NOTICE OF ADDENDUM

ADDENDUM NO. 4

CONTRACT NO. 7528, PROJECT NO. 10305 NAKOOSA TRAIL FLEET/FIRE/RADIO SHOP FACILITY

C1 LOWER ROOF PLAN @ AREA E
1/4" = 1'-0"

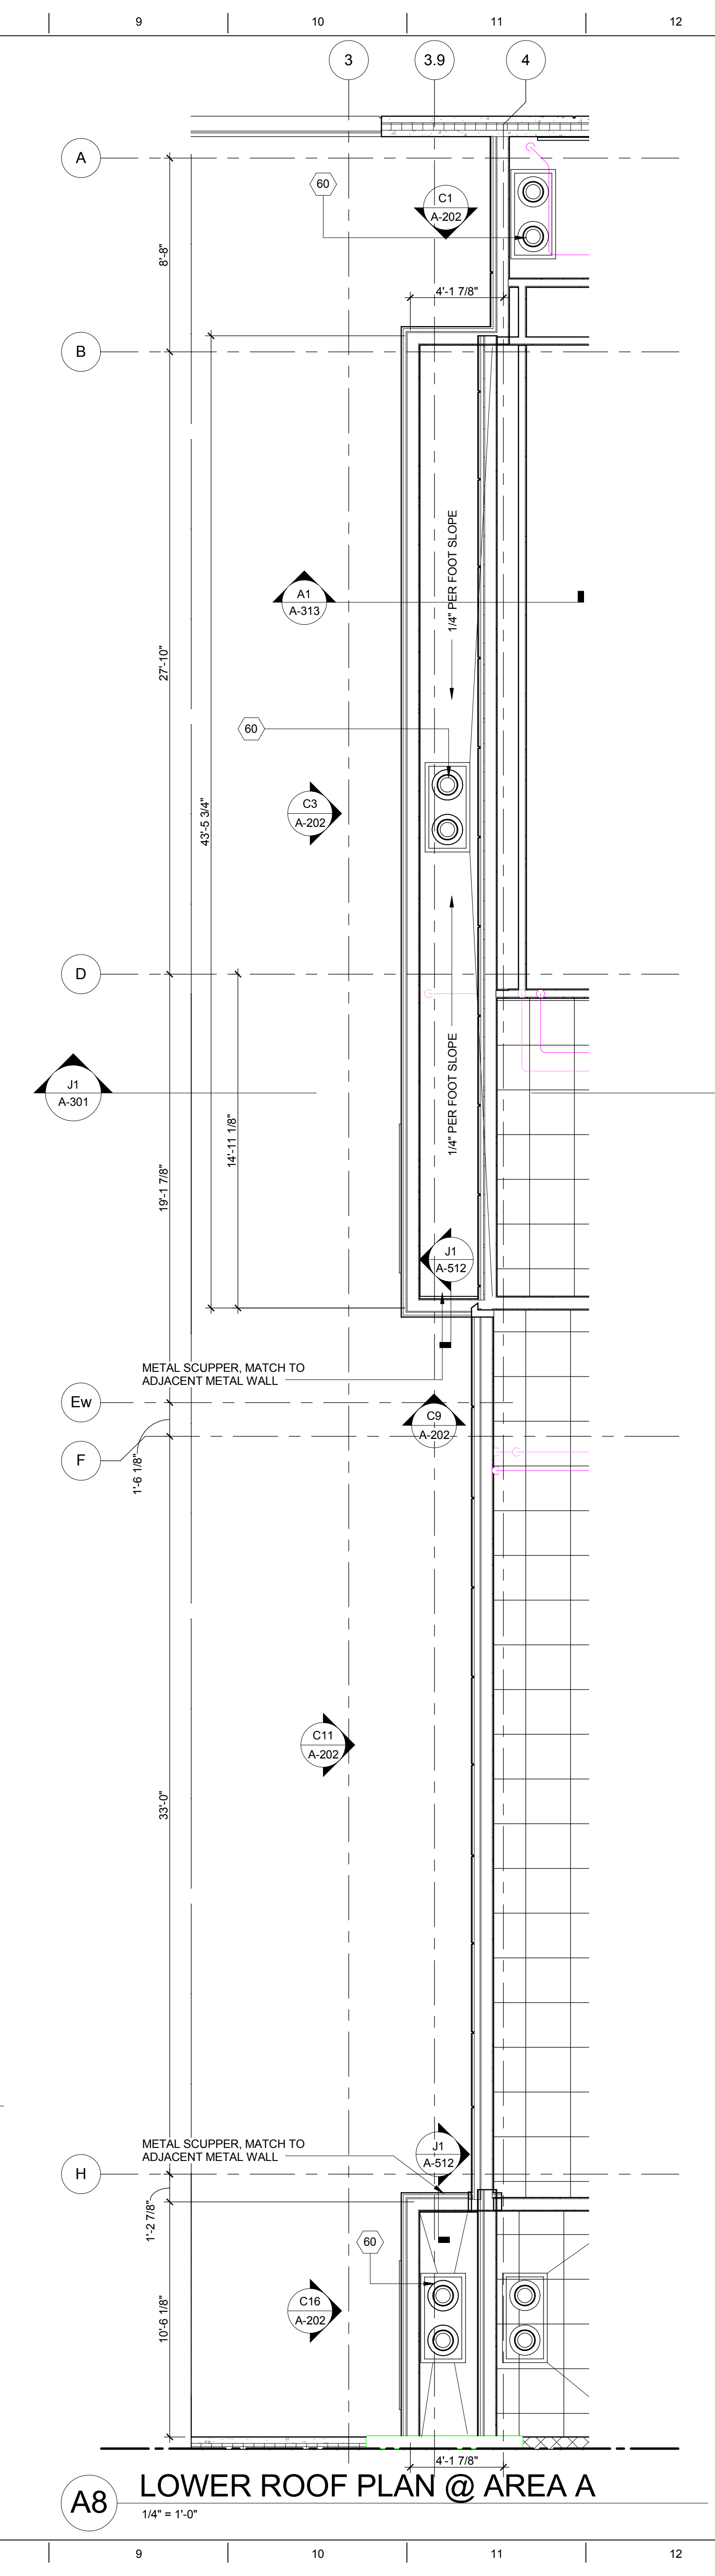
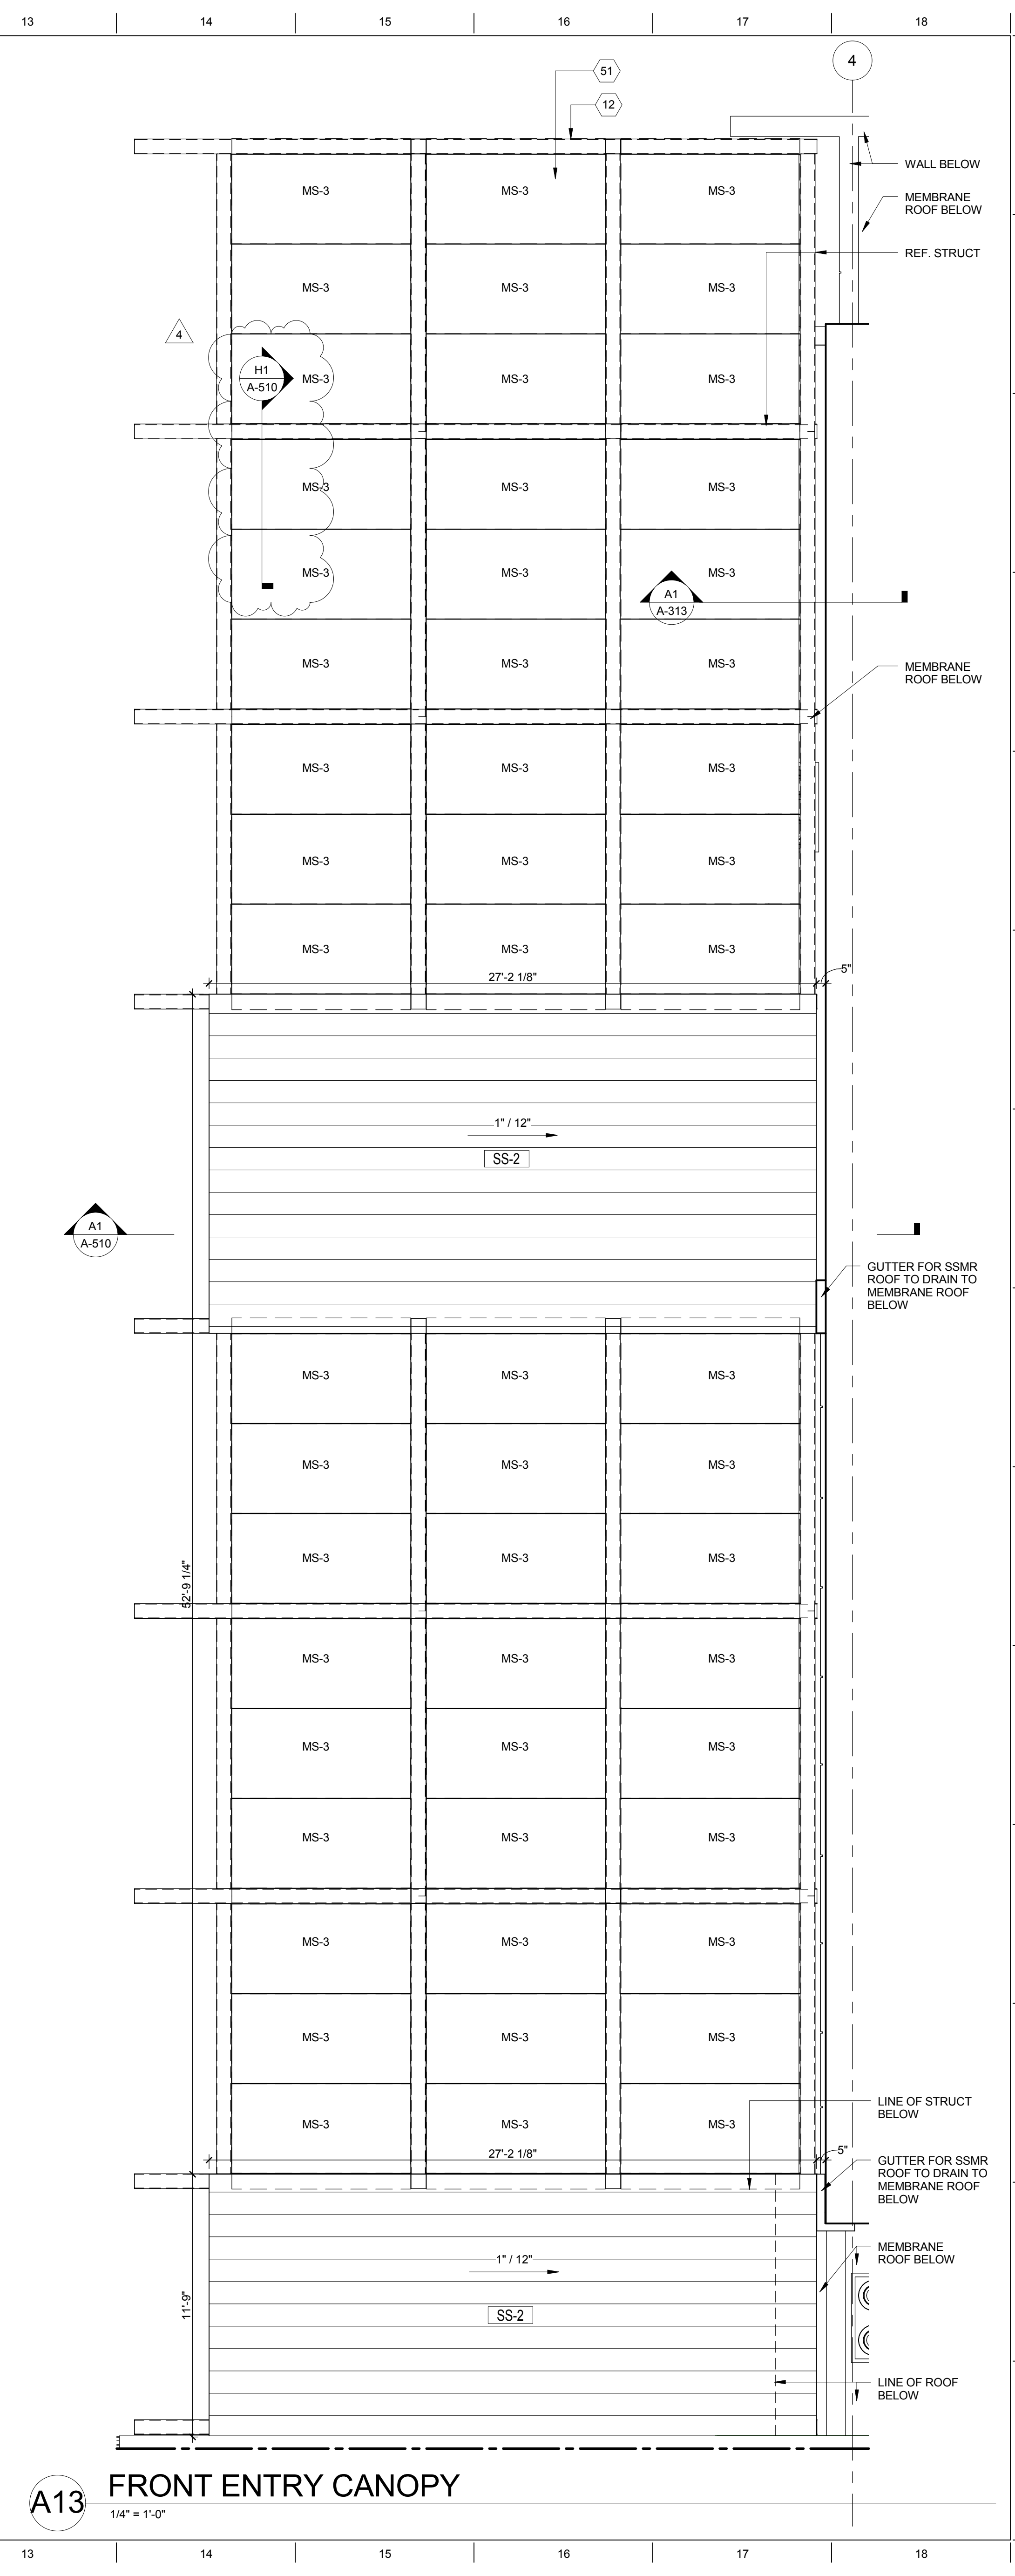
- A. **MODIFIED** A-126 MISC ROOF PLANS with markups of support angle locations at the intermediate sidelap of MS-3 perforated panels. See attached drawing sheet.
- B. **MODIFIED** A-510 CANOPY DETAILS with support angle at intermediate sidelap of perforated panels.
- C. **MODIFIED** S-451 MISCELLANEOUS FRAMING PLANS. See attached drawing sheet.
- D. **MODIFIED** S-601 STRUCTURAL SCHEDULE Add structural column schedule general note:
1. ALL BASEPLATES ARE 3/4" THICK UNO. (Drawing sheet not attached.)
